# UNITED STATES PATENT AND TRADEMARK OFFICE

10/577,719

<b>Office Action Summary</b>	<b>Application No.</b> 10/577,719	<b>Applicant(s)</b> NAKAYAMA ET AL.	
	<b>Examiner</b> SIZO B. VILAKAZI	<b>Art Unit</b> 3747

### **DETAILED ACTION**

FIG. 2

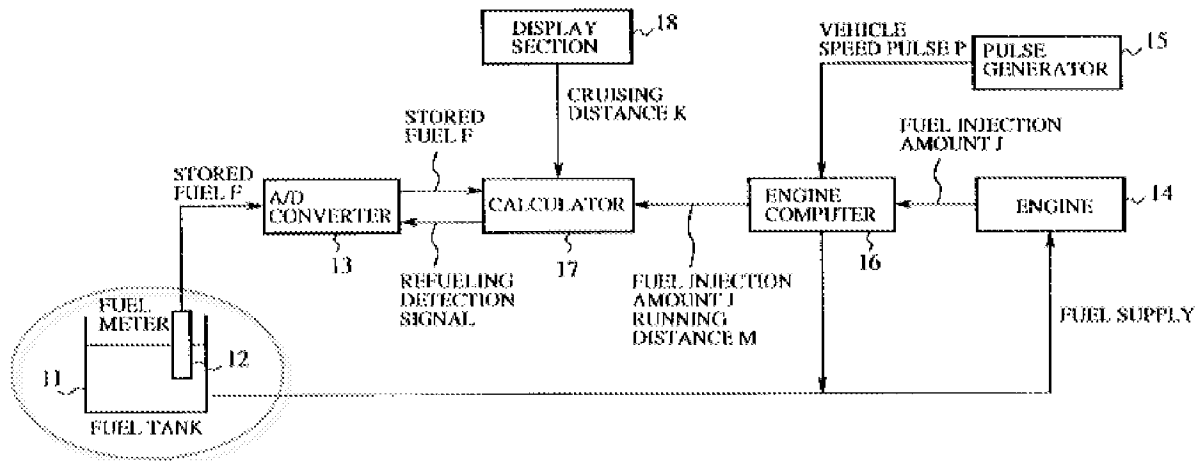
30. In Re claim 9, with reference to Fig. 2, Sadahiro inherently teaches a fuel management system wherein, immediately after said working machine starts and immediately after said working machine stops, said tank contents amount measurement means measures the amount of said contents while said operational value measurement means measures said operational value.
